AERONAUTICAL CHARTING MEETING
Instrument Procedures Group
Meeting 22-02 – October 24-25, 2022

RECOMMENDATION DOCUMENT

FAA Control # 22-02-370

Subject: Order 8260.3E Figure 2-7-2 Misleading

Figure 2-7-2. Simple Restricted Circling Area

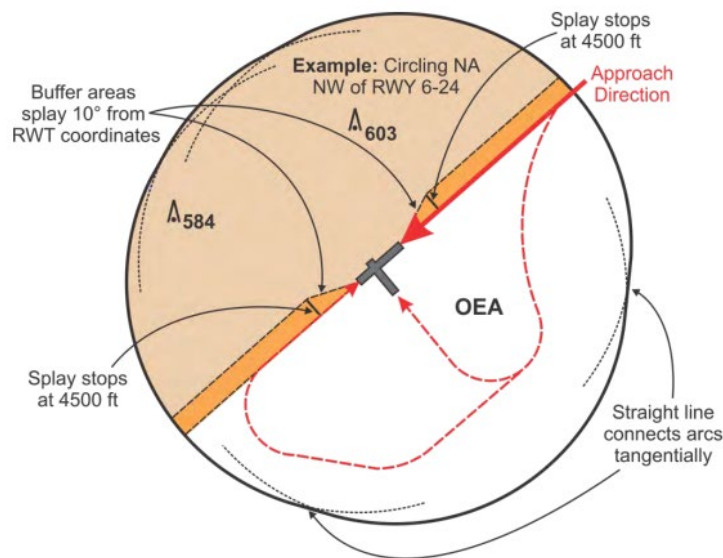
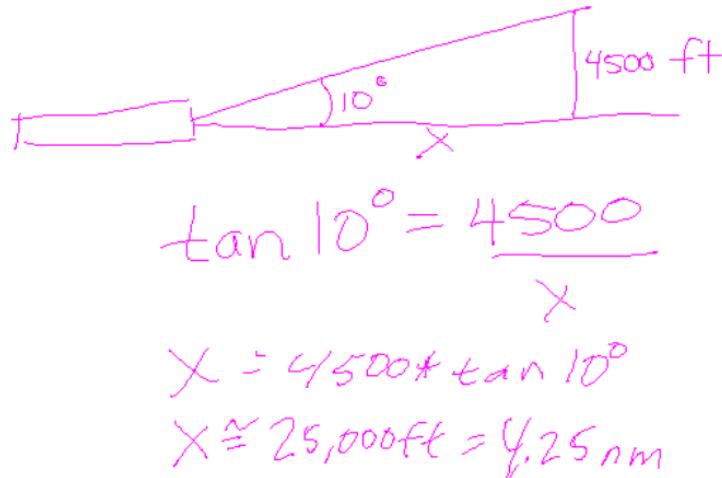
Figure 2-7-2 is an issue because it suggests the splay ends well within the circling area; however, applying the text-described formula leads to the splay stopping 4.25nm from the LTP,

Thus, the image in figure 2-7-2 is misleading because splays, all the way up to Category D below 7000 ft MSL, extend to the edge of the circling area.

A cursory glance at figure 2-7-2 may lead one to assume the splay stops 4500 ft away from the LTP.

Updated Order 8260.3E with a diagram more representative of the splay geometry.
